**NEW RIVER C & TC – ATC RENOVATION  
OMNI ASSOCIATES-ARCHITECTS**

**ADDENDUM NO. 4  
5/05/26**

Ref: **NEW RIVER C & TC – GHENT ATC RENOVATION**

Subj.: ADDENDUM BULLETIN NO. 4

**SITE PLAN - BASE BID- BID ITEM #1**

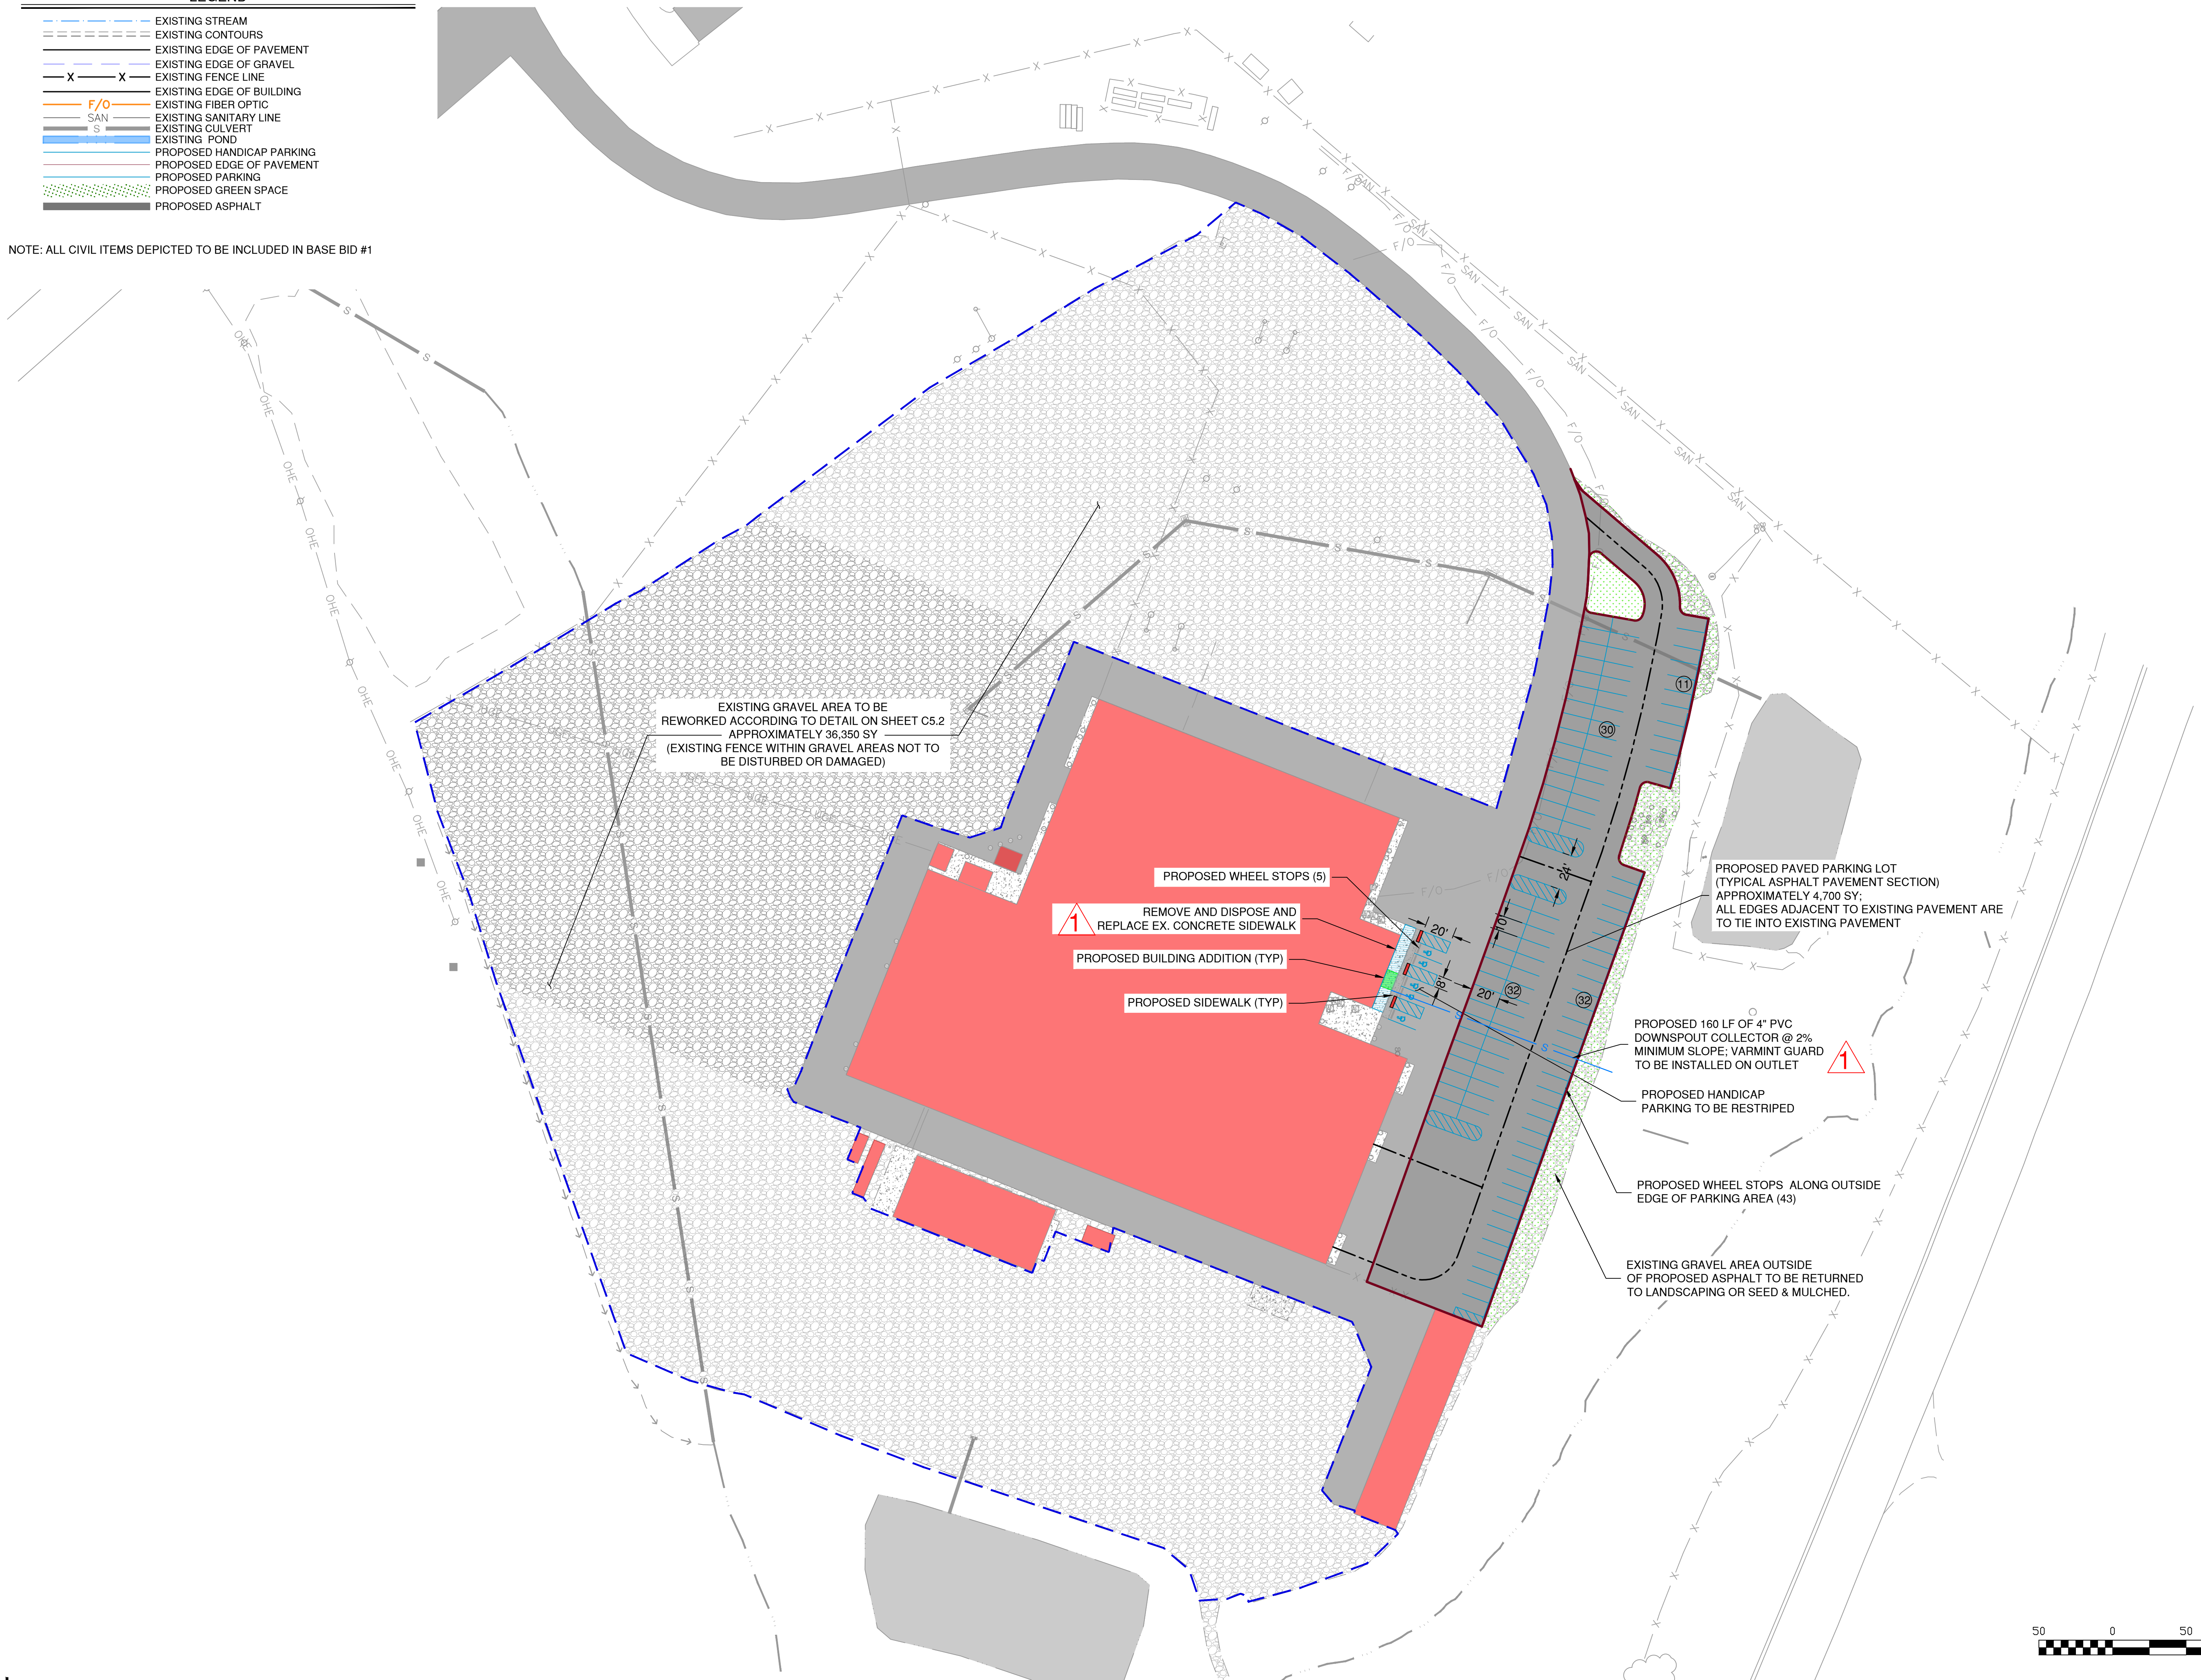
1. **C-3.0:** REPLACE sheet in its entirety, see Enclosures. Updates have been tagged. Revisions related to Add Alternate #03, security gates.
2. **C-3.1:** REPLACE sheet in its entirety, see Enclosures. Updates have been tagged. Revisions related to Add Alternate #03, security gates.

MP-1.1r

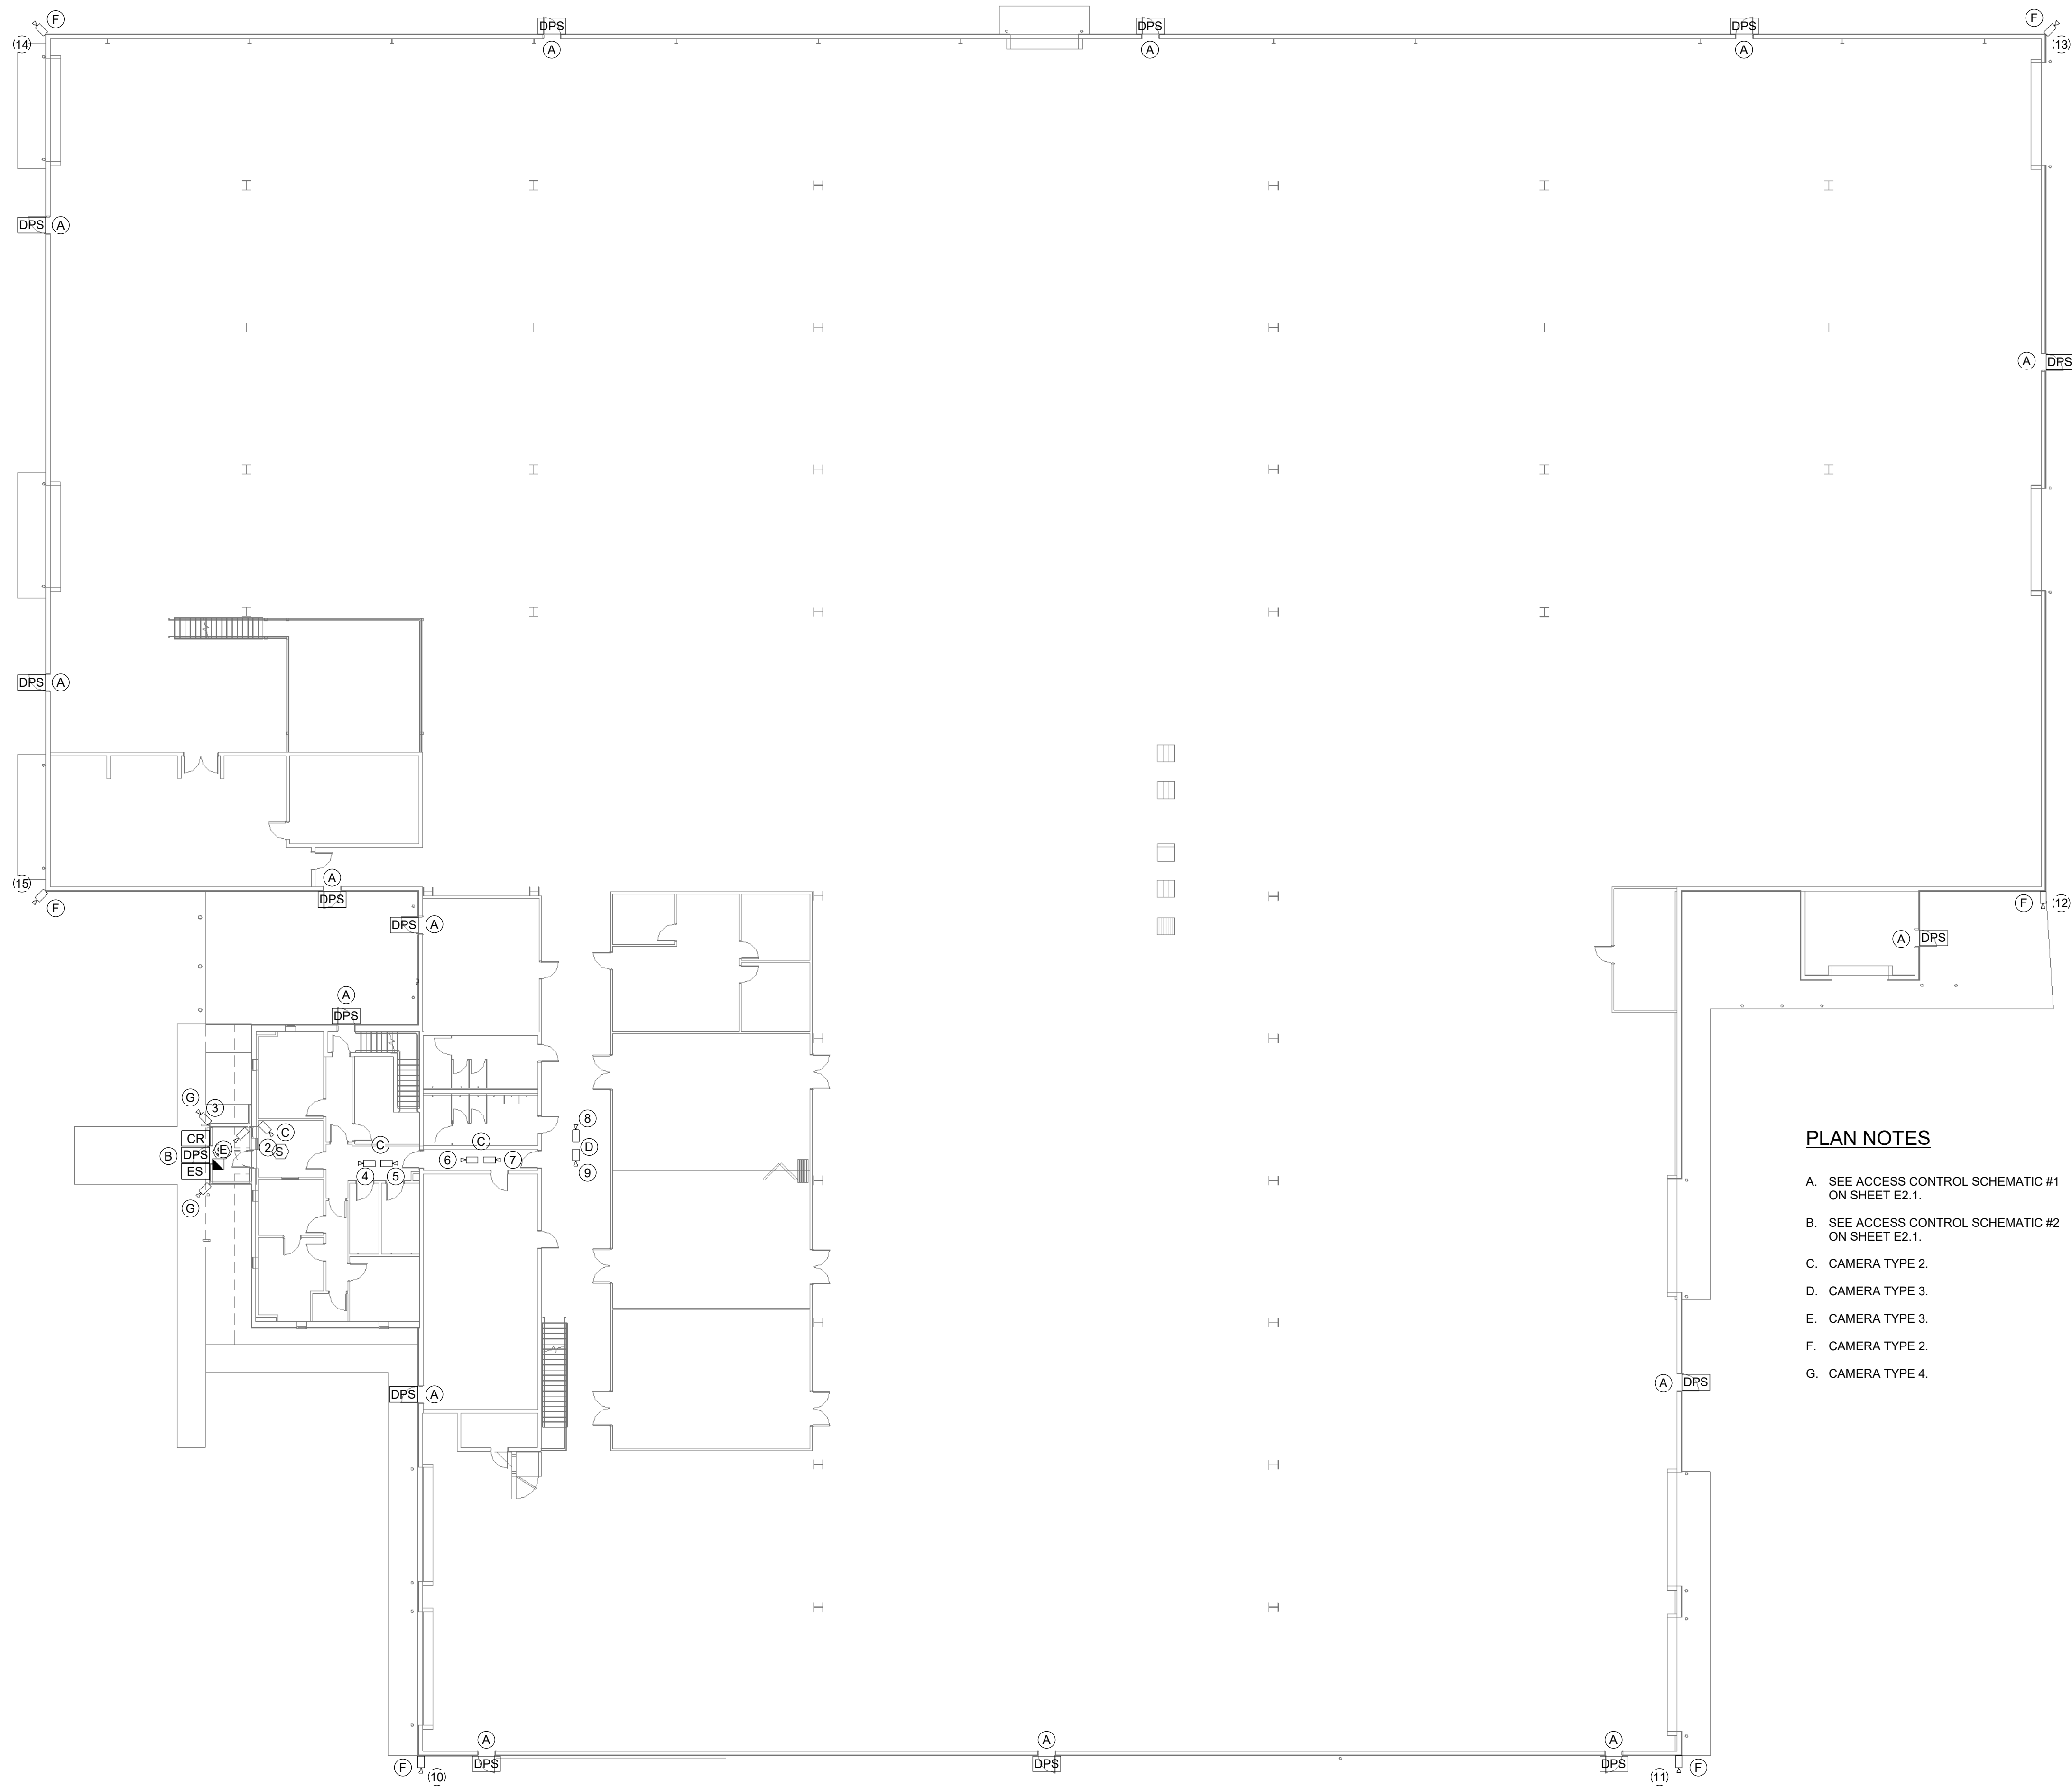
3. **MP-1.1r:** REPLACE sheet in its entirety, see Enclosures. Updates have been clouded and tagged. Revisions related to exterior AHUs.
4. **E-1.1:** REPLACE sheet in its entirety, see Enclosures. Updates have been clouded and tagged. Revisions related to camera layout.

**E-3.2**

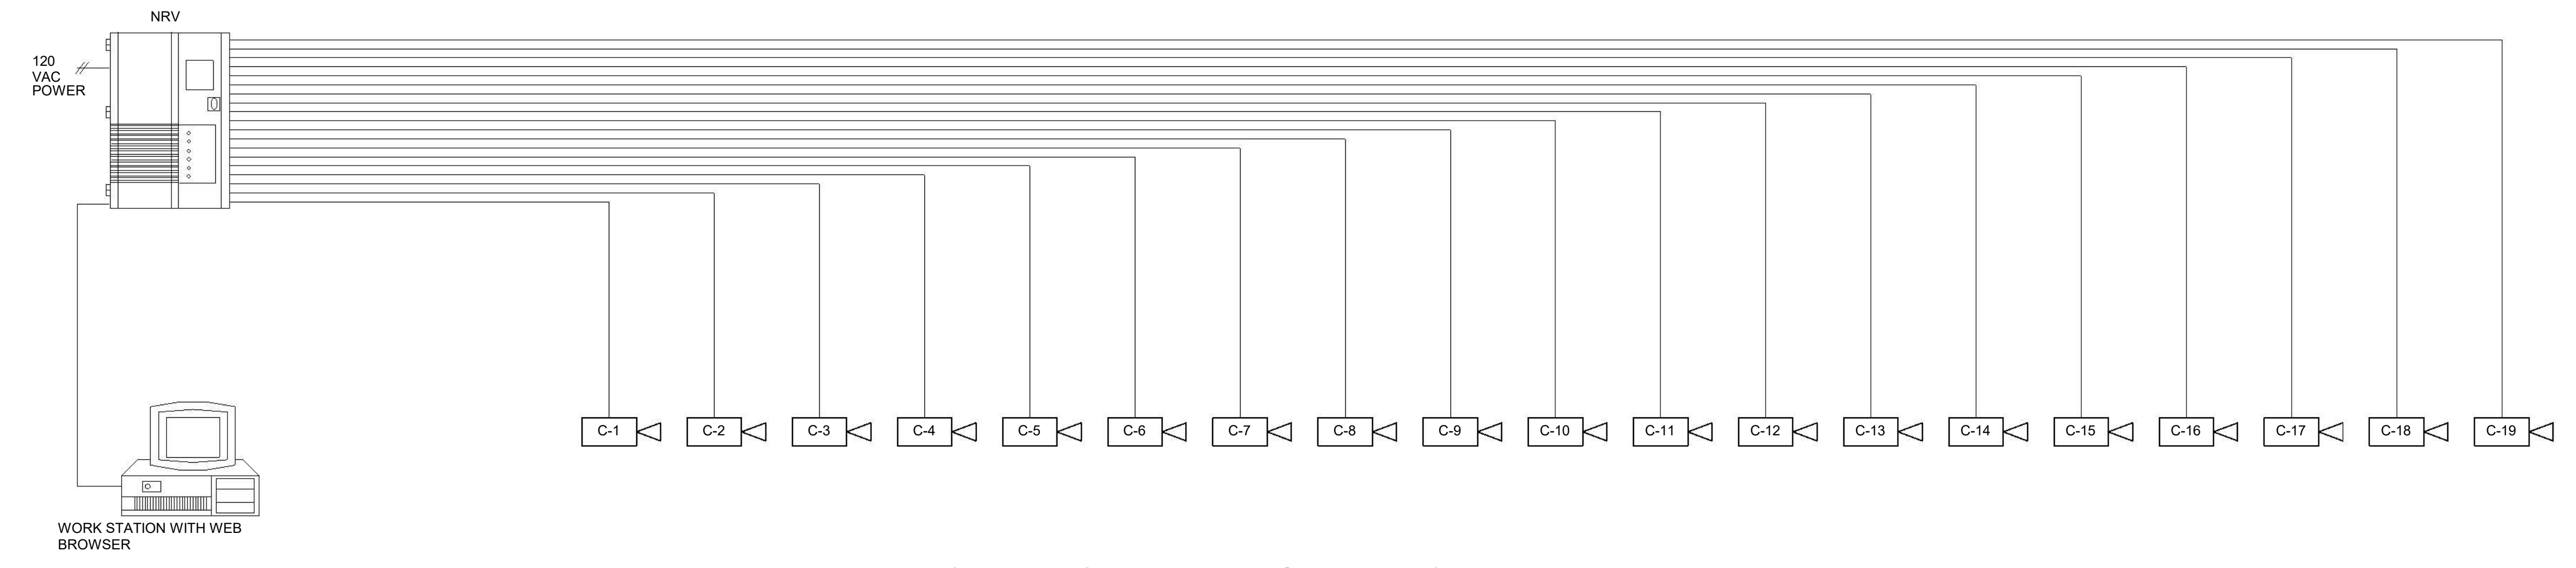
7. **E-3.2:** REPLACE sheet in its entirety, see Enclosures. Updates have been clouded and tagged. Revisions related to camera risers.
